**Detroit  
Edison**

Fermi-2  
6400 North Dixie Highway  
Newport, Michigan 48166  
(313) 586-4150

Subject: Request for Revision to  
Draft Technical Specifications

Detroit Edison requests a change to the draft Fermi 2  
Technical Specifications as indicated in Attachment 1.

THE PURPOSE OF THIS PLAN  
AND SECTION IS TO ILLUSTRATE  
THE ARRANGEMENT OF THE  
SURVEY POINTS LISTED IN  
TABLE 3/4.7.3 -1

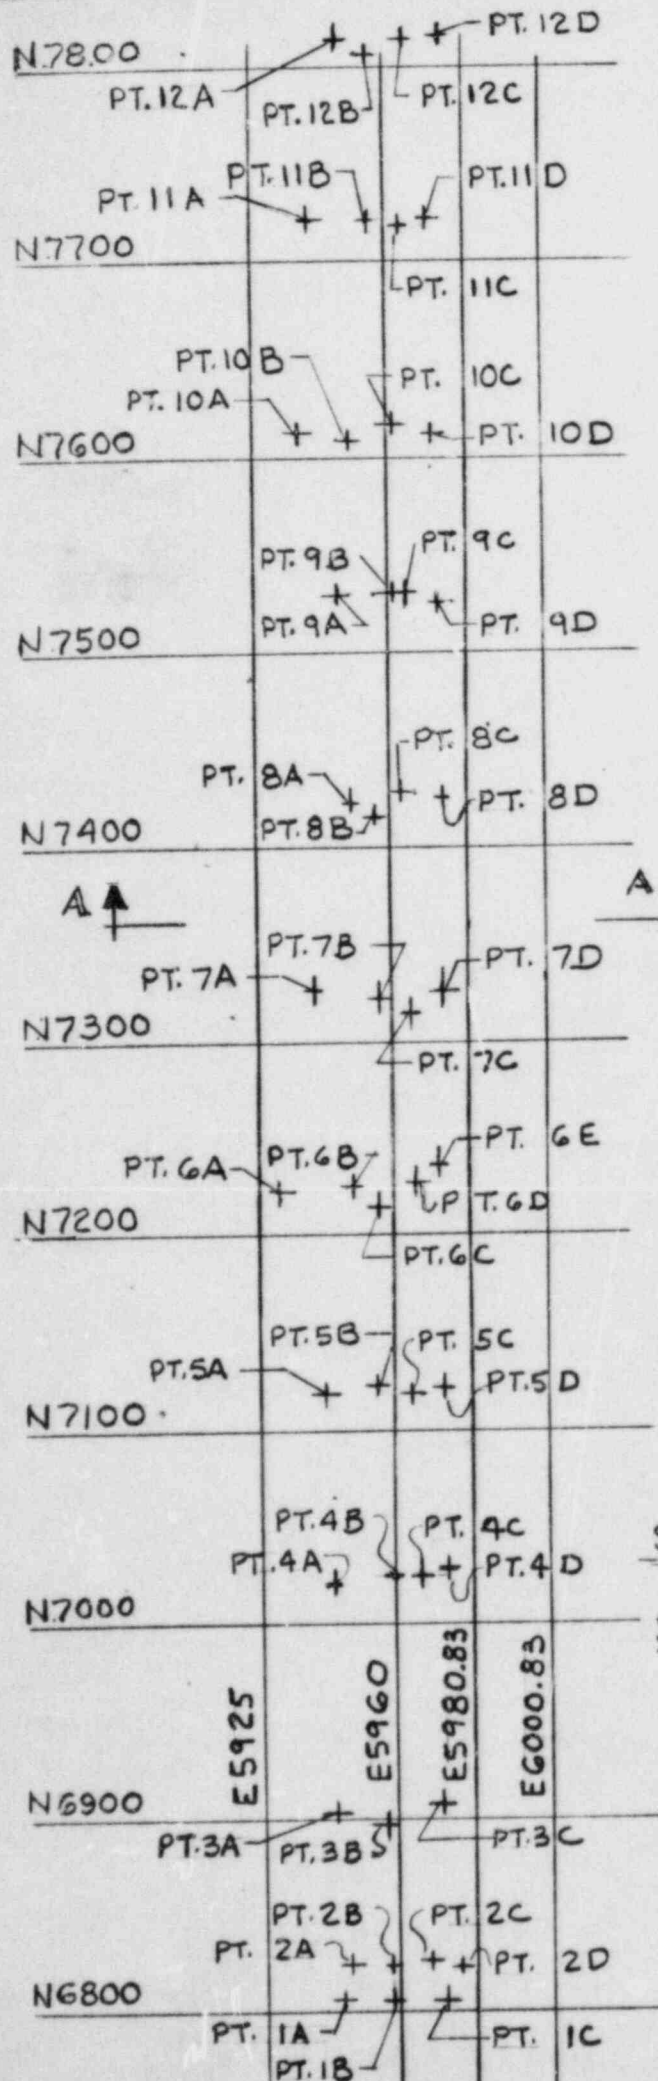
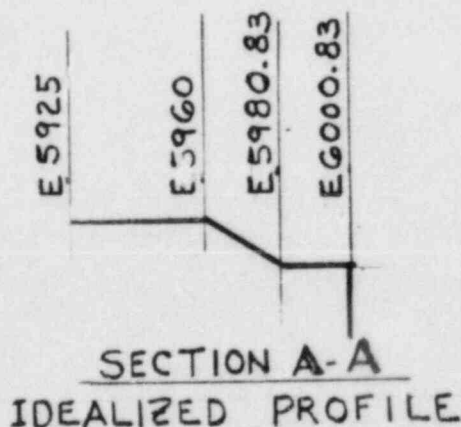
At the request of Mr. Gary Staley of the Environmental and Hydrologic Engineering Branch, Detroit Edison has agreed to modify specification 3.7.3 as indicated in Attachment 1 to include the location and elevation of each survey point on the shore barrier.

3.7.3 The shore barrier shall be structurally sound and capable of limiting wave action as intended. The shore barrier shall be maintained such that the elevation of each survey point listed in Table 3.7.3-1 is not less than 1.0 foot  
APPLICABILITY: At all times, below the elevation listed in the table.

ACTION: determined during the 1984 survey (see Table 3.7.3-1)

With the elevation of one or more survey points different by more than 1 foot from the ~~as-built~~ elevation, prepare and submit to the Commission within 90 days, pursuant to Specification 6.9.2, a Special Report which includes the following information:

1. Measuring reference points are anchored into the capstones using center notched self-drilling bolts.
2. See Figure B3/4.7.3-1 for location sketch.

FIGURE 1  
SECONDARY CONTAINMENT RESPONSE  
DUE TO A DBA-LOCA

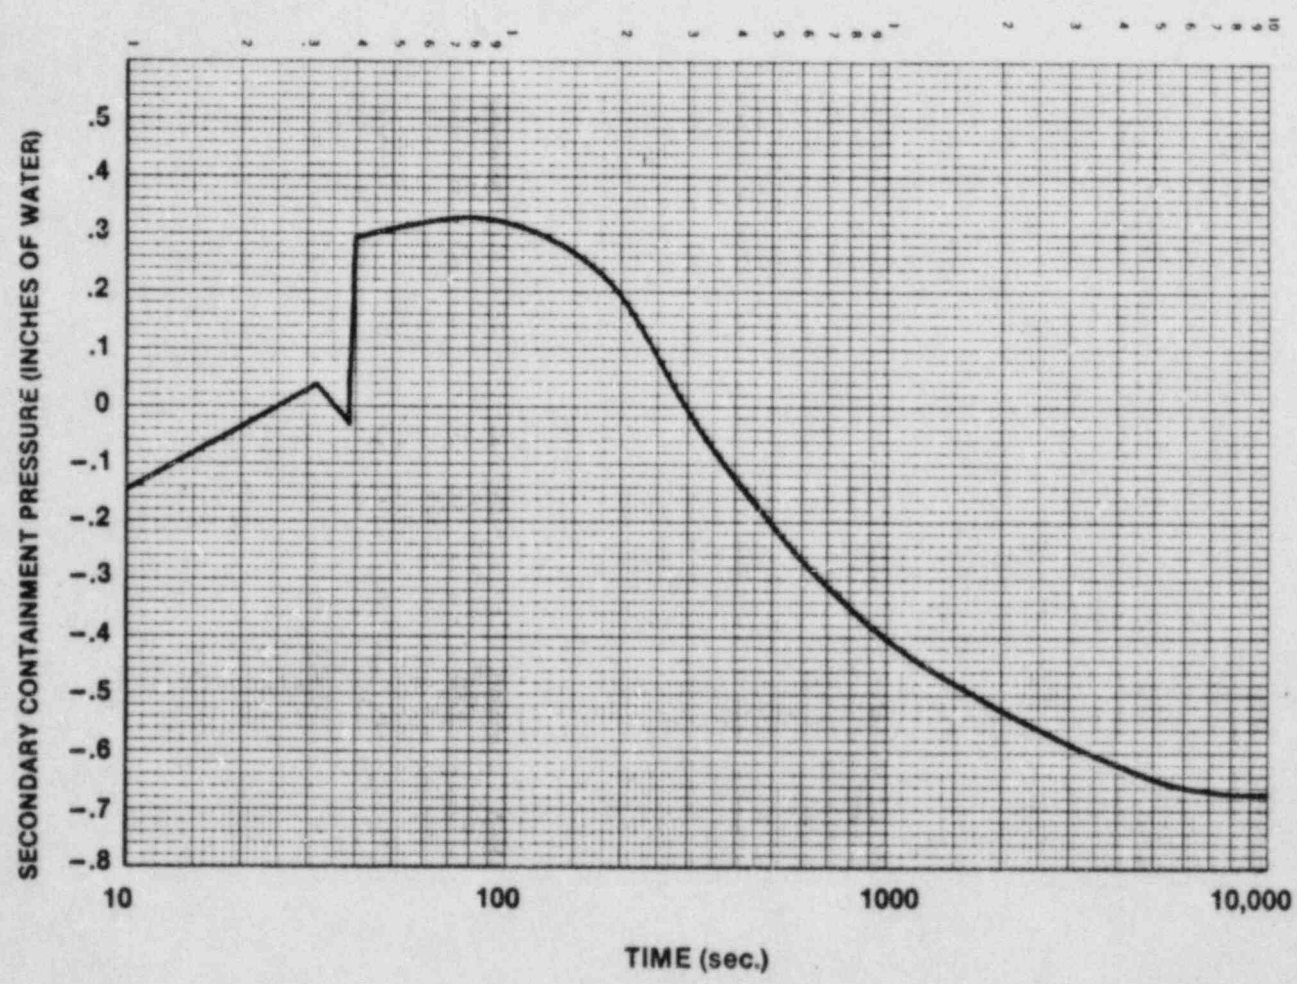
Attachment 2 consists of a revision to the Final Safety Analysis Report which will be incorporated in a future amendment. It reflects a revised analysis of the time required to restore a negative pressure in the secondary containment following a design-basis LOCA. This analysis supports the technical specification on normal secondary containment pressure as discussed previously with Mr. John Lane of the Containment Systems Branch.

The secondary containment response due to a DBA-LOCA is shown in Figure 1. During the first 33 seconds, the pressure increases to a slightly positive value. With the activation of the SGTS at 33 seconds and the activation of the area coolers at 38 seconds, the pressure decreases to near atmospheric.

At ~~33~~ <sup>36</sup> seconds, pressure-relieving doors on the common wall between the torus room and the corner rooms open and allow heated torus room air to enter the rest of the secondary containment. This step input of heat into the secondary containment appears as a sharp pressure spike on Figure 1.

replace with attached sketch
